**DRAFT
PROPOSED ACTION MEMORANDUM
FOR THE SOURCE REMOVAL AT
TRENCH 1
IHSS 108**

May 14, 1997

Revision 3

Document Control Number RF/RMRS-97-011

Figure 2-1
Mound and Trench 1
Borehole and Groundwater
Well Location Map

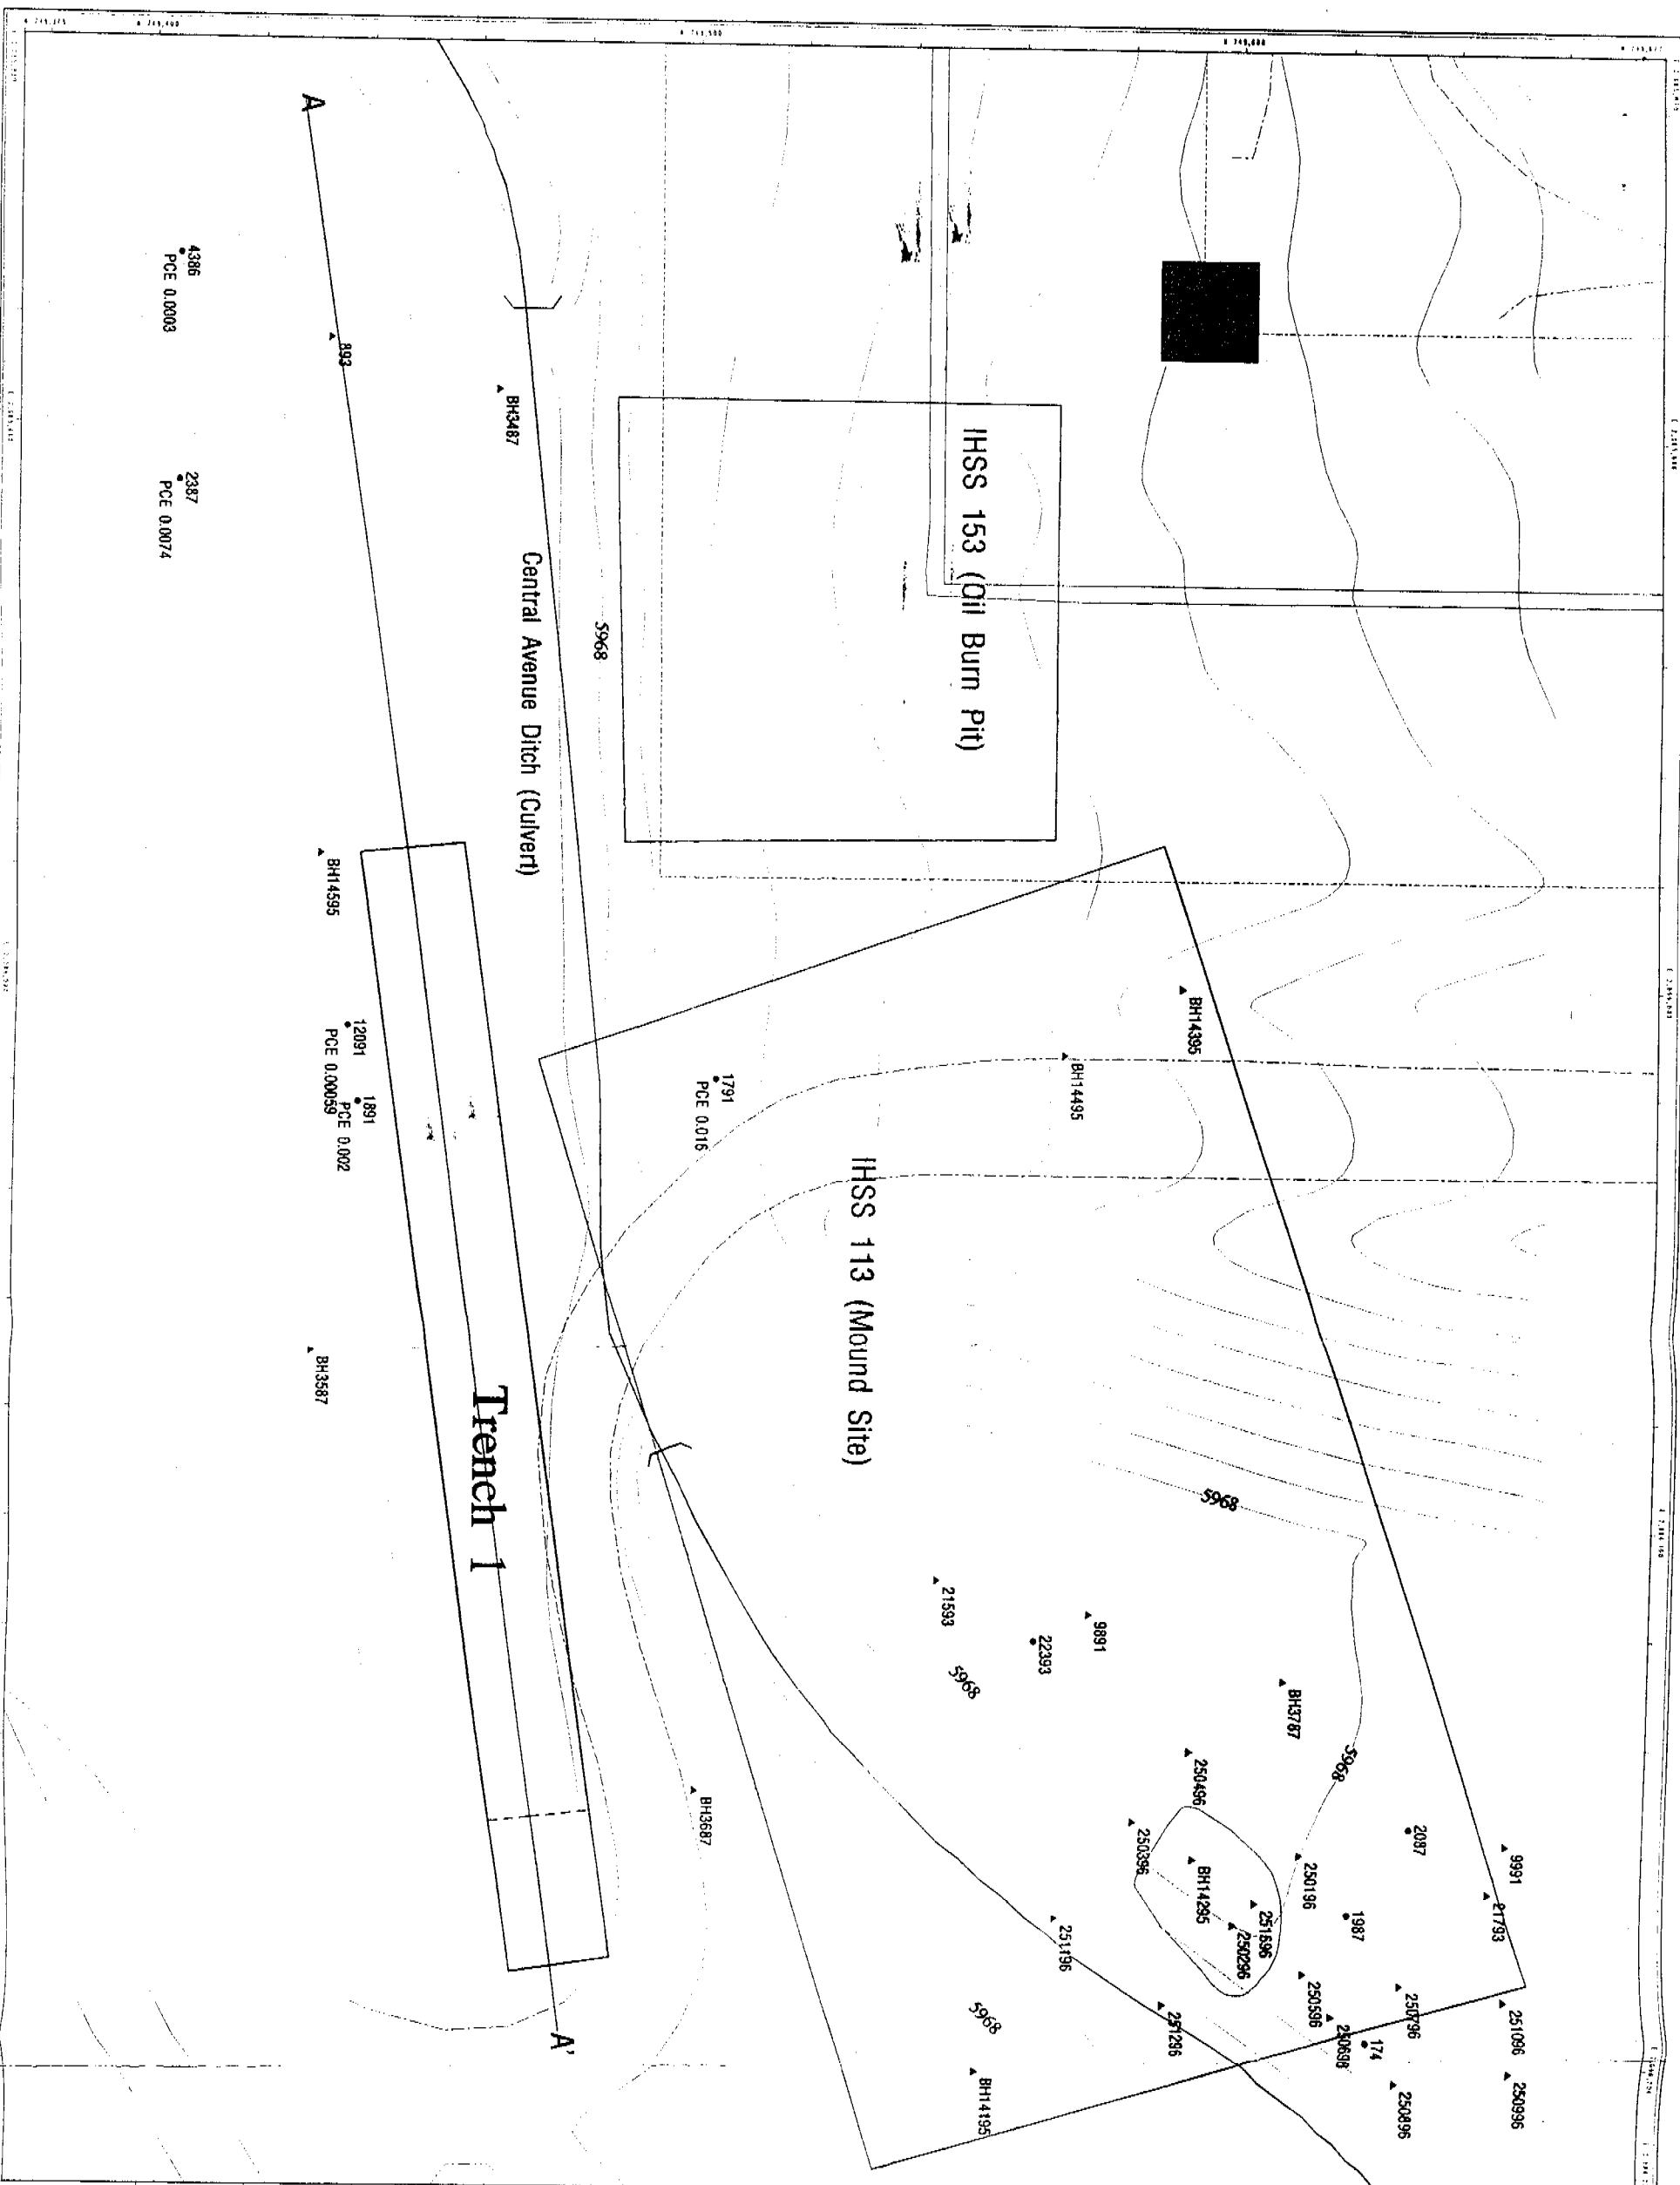
Comment #15: The discussion in Section 2.4.2 under Metals in Soils and Radionuclides in Soils (page 11) needs to state that the boreholes are all well outside the trench and explain how the analytical results are applicable to this proposed action. The location of the boreholes makes the data listed in Table 2-2 almost irrelevant. This same comment applies to the discussion under Soil Gas Survey on page 13.

Response #15: *The borehole data is presented to evaluate all available data for the trench area as stated in the first paragraph of Section 2.4. However, Section 2.4.2 will be clarified as follows:*

Subsurface soil samples were collected from three boreholes (BH3487, BH3587, and BH3687) in the vicinity of T-1 (see Figure 2-1). The boreholes are located well outside of the trench area. Subsequently, the available borehole data does not represent subsurface conditions within the trench. Subsurface soil sampling fromcobble material encountered.
